**Location:** Body Exterior - Exterior Ornamentation

**Topic:** Rear bumper exhaust heatshield coming loose

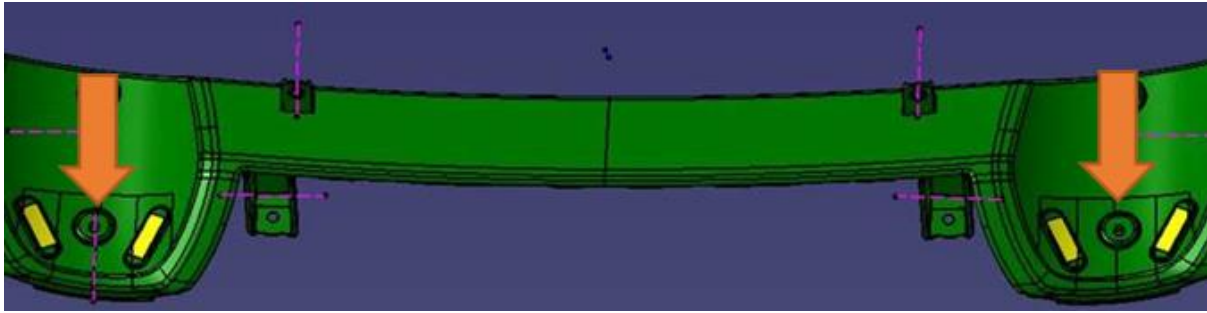
On early production 720S vehicles, the exhaust heatshield on the rear bumper may come lose.

This is due to the adhesive used to install this part to the bumper not being appropriate for this application (high temperature).

A new design of the exhaust heatshield has now been introduced. The new heatshield now has 2 studs an inner and an outer one to secure it on the rear bumper extension.

1. Remove the old heatshields and clean the area of any adhesive, tape and other contamination
2. Depending on the manufacturing date of the vehicle, the type of heatshields fitted may be different. There are two different type of heatshields, with the difference being the number of studs/fixings on the underside surface.
3. Observe the removed heatshields to identify the number of studs / fixings:
  - If the removed heatshields have **two** studs (outer stud is glued) - see image below - use the existing holes onto the bumper extension to fit the new heatshields

- If the removed heatshields have only **one** stud on the inner side, a new hole needs to be drilled between the two tape holders in the bumper extension - see image below. Use the new heatshield as guide by partially inserting the inner stud to the existing hole and use the outer stud to align and mark the spot where the new hole needs to be drilled
